# TECHNICAL BULLETIN

## Steering Pull – Correction Procedure

**60-7**

MODEL Sedan Range 1988 - 94 MY

ILLUSTRATION 1

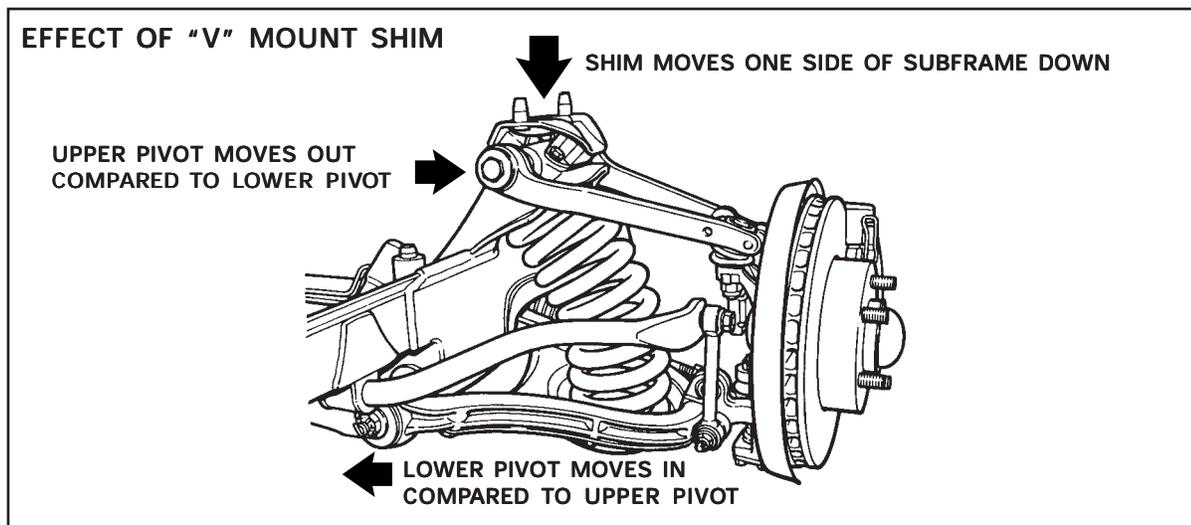
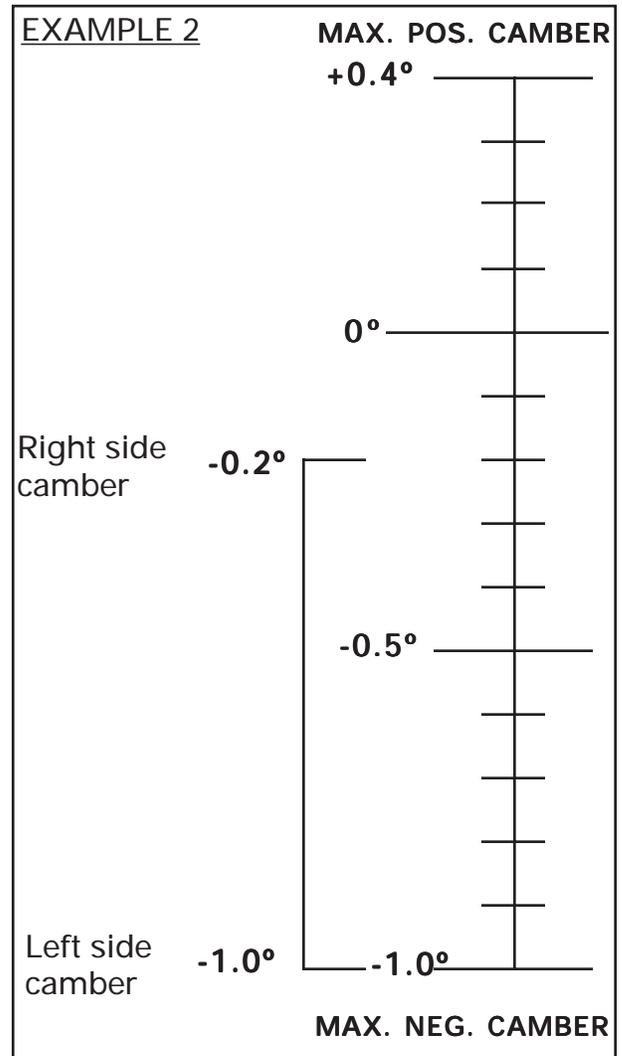
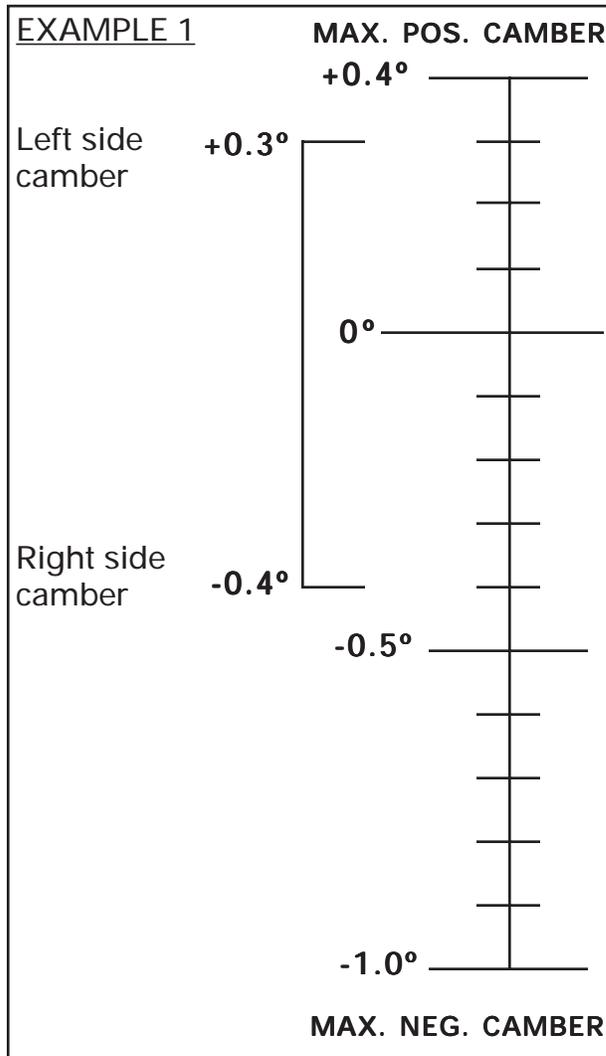
- After ensuring that the alignment is within specifications (+4° to -1.0° camber) and that no suspension components are bent, ADD shims to the side of the vehicle with the MORE NEGATIVE (LESS POSITIVE) measurement.
- Shimming one "V" mount causes the camber on that side to change toward a more positive (less negative) measurement (Illustration 1). At the same time, camber on the side opposite the shim moves toward more negative (less positive). This change has an equalizing effect that reduces the camber imbalance.
- Each 1 mm shim corrects 0.1° of camber imbalance. The shims must not exceed a total thickness of 3 mm.
- Two examples are given on page 3.

EXAMPLE 1

Left side camber = +0.3°

Right side camber = -0.4°

$$\begin{aligned} \text{Camber imbalance} &= 0.3 - (-0.4)^\circ \\ &= \underline{0.7}^\circ \end{aligned}$$

**Action:**

Insert 3 shims on right side "V" mount to reduce imbalance to 0.4°.

EXAMPLE 2

Left side camber = -1.0°

Right side camber = -0.2°

$$\begin{aligned} \text{Camber imbalance} &= -1.0 - (-0.2)^\circ \\ &= \underline{-0.8}^\circ \end{aligned}$$

**Action:**

Insert 3 shims on left side "V" mount to reduce imbalance to -0.5°.

ILLUSTRATION 2

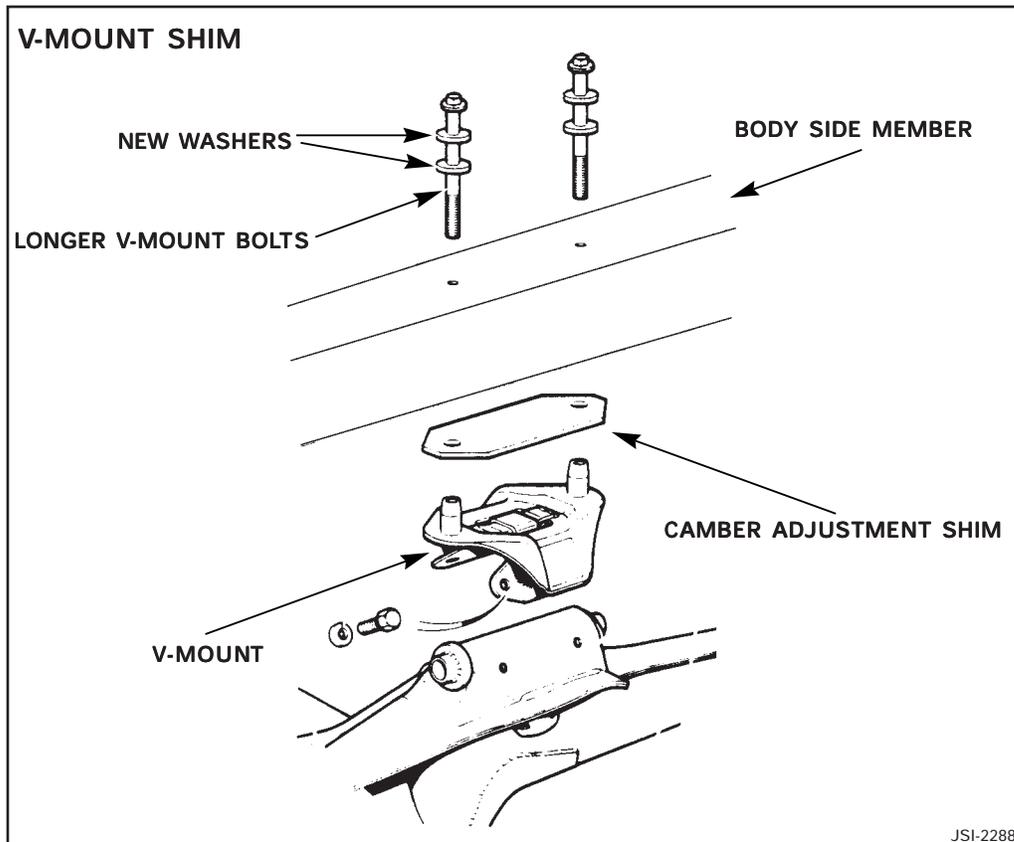
- The camber adjustment shims are installed between the side member and the V-mount (Illustration 2).

**NOTE:** When shims are installed, the existing bolts, must be replaced by longer bolts, part no. JZB 100057, along with 2 washers, part no. C 21069 between the head of each bolt and the upper surface of the side member.

ILLUSTRATION 3

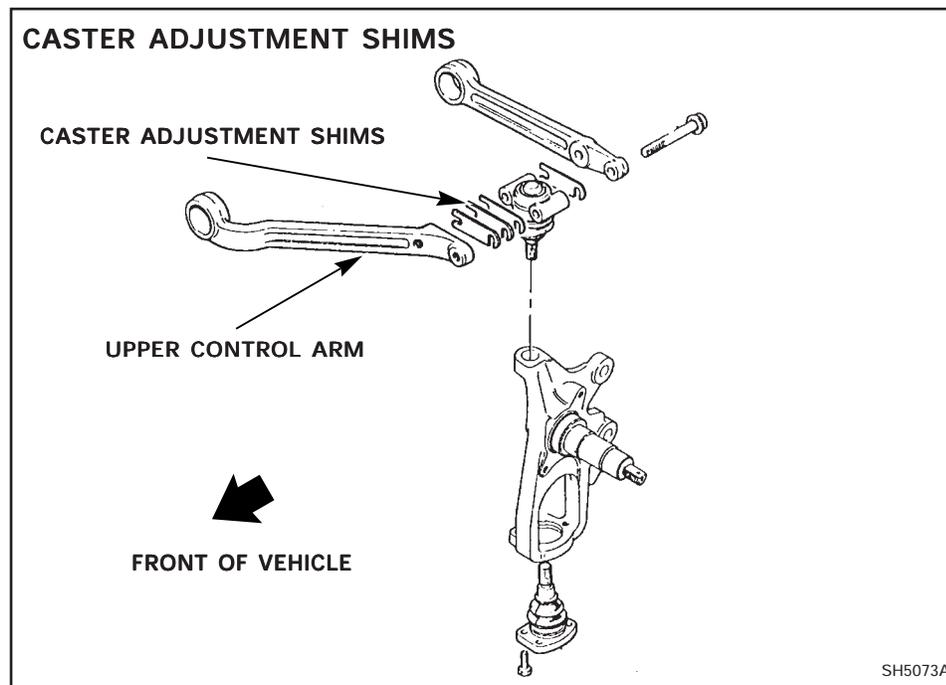
- Caster is adjusted by transferring shims from one side of the upper ball joint to the other (Illustration 3). Do not change the total amount of shims by adding or subtracting shims.

**NOTE:** The caster measurement must remain within the specifications of +2° to +7°.

For example, to reduce a pull to the right:  
INCREASE the Caster angle on the RIGHT side to become MORE positive, or  
DECREASE the caster angle on the LEFT side to become LESS positive,  
to bias the steering to the LEFT.
